UNITED STATES PATENT AND TRADEMARK OFFICE

APPLICATION NO.	FILING DATE	FIRST NAMED INVENTOR	ATTORNEY DOCKET NO.	CONFIRMATION NO.
10/645,047	08/21/2003	Sampath Purushothaman	YOR920030029US2 (16841)	6546
23389 7590 05/14/2007 SCULLY SCOTT MURPHY & PRESSER, PC 400 GARDEN CITY PLAZA SUITE 300 GARDEN CITY, NY 11530			EXAMINER GRAYBILL, DAVID E	
			ART UNIT 2822	PAPER NUMBER
			MAIL DATE 05/14/2007	DELIVERY MODE PAPER

Office Action Summary

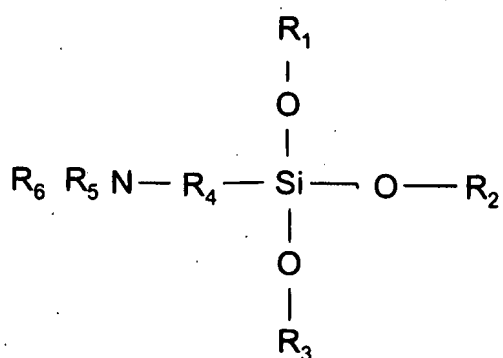
In the instant specification, paragraphs 3-18, 39, 45, 48, 51-54, 56 and 60, applicant admits as prior art the following:

A structure for interconnecting semiconductor components comprising: a layered substrate 100 for transferring; said layered substrate is terminated with a terminal layer (portion of 103, on which, is bi-layer capping coating 200) that includes at least one metallic component; a bi-layer capping coating 200 on top of the layered substrate, each layer of said coating provides adhesion and protection; said bi-layer capping coating comprising a

first layer of an amino silane entirely on said terminal layer including said at least one metallic component and a second layer of an amino silane atop said first layer of amino silane; and a carrier assembly 300, 400, 500; wherein said substrate to be transferred contains at least one semiconductor component; wherein said at least one semiconducting component is selected from the group consisting of semiconductor devices, semiconductor circuits, thin-film layers, passive and/or active elements, interconnecting elements, memory elements, micro-electro-mechanical elements, optical elements, optoelectronic elements, and photonic elements; wherein said carrier assembly comprises a carrier wafer 500, an adhesive layer 400 and an intermediate layer 300; wherein said carrier assembly comprises glass and an intermediate layer of polyimide; wherein said carrier wafer is selected from the group consisting of silicon, silicon-on-insulator, silicon germanium-on-insulator, alumina, quartz, Group III-V or II-VI semiconductor wafers, and ceramics; wherein said metallic component is a patterned wiring level or a blanket film; wherein said metallic component is selected from the group consisting Ti, Ta, Zr, Hf, their silicides nitrides and their conducting siliconitrides; Cu, Al, composites of these materials with glass; and combinations thereof; wherein said capping coating provides passivation to the metallic component; wherein said capping coating comprises: a first layer that serves as a diffusion barrier, while providing adhesion to the

substrate; and a second layer that is capable of providing adhesion to the carrier assembly and is an additional diffusion limiting layer; wherein said second layer comprises an amino silane and is an adhesion promoter to an intermediate layer 300; wherein said amino silane is a compound of the formula:

To further clarify, in addition to admitting as prior art the bi-layer capping coating 200 entirely on the portion of 103, on which, is the capping coating, applicant also admits as prior art the bi-layer capping coating entirely on the terminal layer "spun," also see 5081005, 5194928 and Perfecto. In any case, applicant's admitted prior art and the invention are identically disclosed, including in the drawings, except that the prior art "capping layer 200 in this scheme [the invention] is substituted by a capping layer 200'," and there is no original disclosure of the claimed capping coating entirely on the terminal layer additive to that of the admitted prior art. Therefore, any original disclosure for the claimed capping layer entirely on the terminal layer also constitutes original disclosure for the admitted prior art capping layer entirely on the terminal layer.

To further clarify, applicant admits as prior art a bi-layer capping coating comprising a first layer of an amino silane entirely on said terminal layer including said at least one metallic component and a second layer of an amino silane atop said first layer of amino silane because applicant admits as prior art an amino silane capping coating having "a few monolayers." Furthermore, as cited, applicant discloses as prior art "a capping layer," and it is well settled that the term "a" or "an" ordinarily means "one or more."

However, applicant does not appear to explicitly admit as prior art wherein said bi-layer capping coating comprising a first layer of silicon nitride entirely on said terminal layer, and said first layer protects from an oxygen-based plasma removal process.

Moreover, it would have been obvious to combine this disclosure of Van Andel with applicant's admitted prior art by substituting the bi-layer capping coating 20 of Van Andel for the capping coating 103 of applicant's admitted prior art, because, as disclosed by Van Andel as cited, it would desirably passivate the semiconductor component of the admitted prior art.

Moreover, because applicant's admitted prior art amino silane layer 200 is entirely over the terminal layer, even without relying on Van Andel for the disclosure of the silicon nitride entirely on the terminal layer, the direct substitution of the bi-layer capping coating 20 of Van Andel for the admitted prior art amino silane layer entirely on the terminal layer would provide a first layer of silicon nitride entirely on the terminal layer.
